Hi Limit Replacement

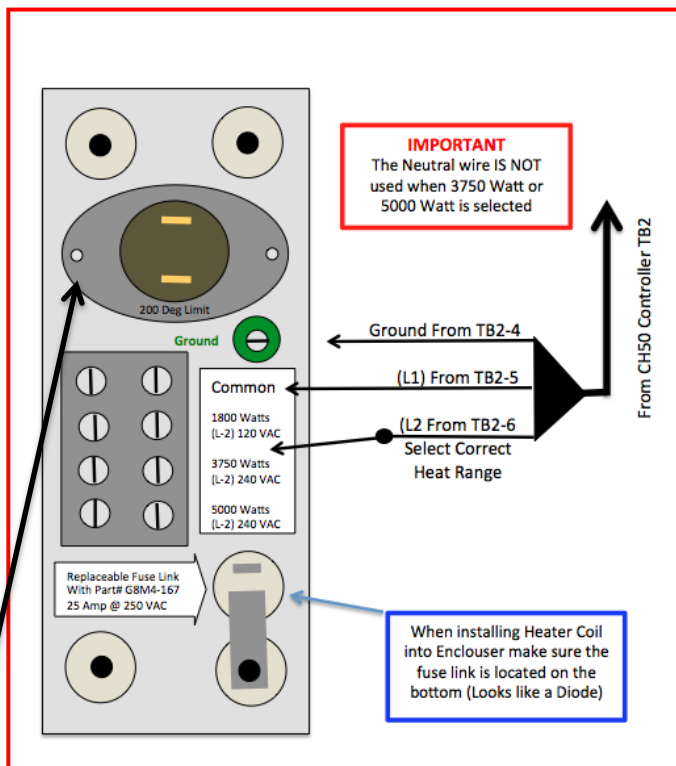
When using the heater coil in a vertical configuration the Auto Limit Switch needs to be upgraded to 200 F Degree switch to eliminate short cycling.

- If heater is used in a horizontal configuration the auto temperature switch needs to remain at the factory installed 155 f degree switch.
- After upgrade before installing heater coil complete resistance test on all heater coils and make sure the readings match the chart below.
- Make sure that furnace has adequate ductwork for heater setting as specified in installation manual.
- On vertical configurations make sure their is no hidden duct work is connected to the bottom side of the furnace that hasn't been rerouted to the end of the CheapHeat™ cabinet adapter.

1. Unplug 2 wires form Limit Switch.
2. Remove 2 screws and nuts (*back side of panel*).
3. Remove Limit Switch
4. Install new 155 F (Horz.) or 200 F (Vert.) Degree
5. Reinstall 2 screws with nuts.
6. Reconnect 2 wires (*you may need to retighten stake-on's before sliding them back on clips to make sure they are tight*).
